# Access Compliance Report

## Public Rights-of-Way

Intersection ID: 21454	Main Street: SARDIS_RD_NORTH	Cross Street: MAPLE_SHADE_LN	Location: NE
ADA ID: DF8B2688B65B	Ramp Type: PerpDiag	Initial Pass/Fail: Fail	Overall Compliance: No
		Severity Score: 37.5

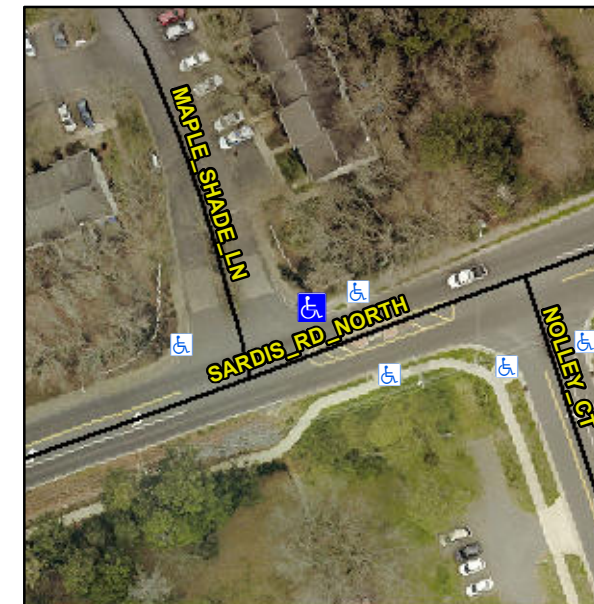
**R304.2.2, R304.5.3**

Compliance	Description	Data	Compliance	Description	Data
N/A	Ramp Length (in)	59.0	No	Ramp Slope (%)	9.0
Yes	Ramp Width (in)	48.0	No	Ramp XSlope (%)	9.7
N/A	Flare Type LT	N/A	N/A	Flare Type RT	N/A
N/A	Flare Slope LT (%)	N/A	N/A	Flare Slope RT (%)	N/A
N/A	Flare Traversable LT?	N/A	N/A	Flare Traversable RT?	N/A
N/A	Landing Length (in)	N/A	N/A	DWS Provided?	N/A
N/A	Landing Width (in)	N/A	N/A	DWS Contrast?	N/A
N/A	Landing Slope (%)	N/A	N/A	DWS Length (in)	N/A
N/A	Landing X Slope (%)	N/A	N/A	DWS Full Width?	N/A
N/A	Landing Curb? (Y/N)	N/A	N/A	DWS Offset (in)	N/A
N/A	Shared Landing?	N/A			
N/A	Gutter Ponding?	N/A	N/A	Gutter Slope (%)	N/A
N/A	Gutter Lip Ht (in)	N/A	N/A	Gutter X Slope (%)	N/A
N/A	Painted X Walk1?	No	N/A	Painted X Walk2?	No
	X Walk 1 Direction	To W		X Walk 2 Direction	To S
N/A	X Walk 1 Width (in)	N/A	N/A	X Walk 2 Width (in)	N/A
	X Walk 1 Slope (%)	2.9		X Walk 2 Slope (%)	7.9
	X Walk 1 X Slope (%)	7.8		X Walk 2 X Slope (%)	0.7

**Remove & Replace Curb Ramp With Two New Directional Ramps or Equivalent.**
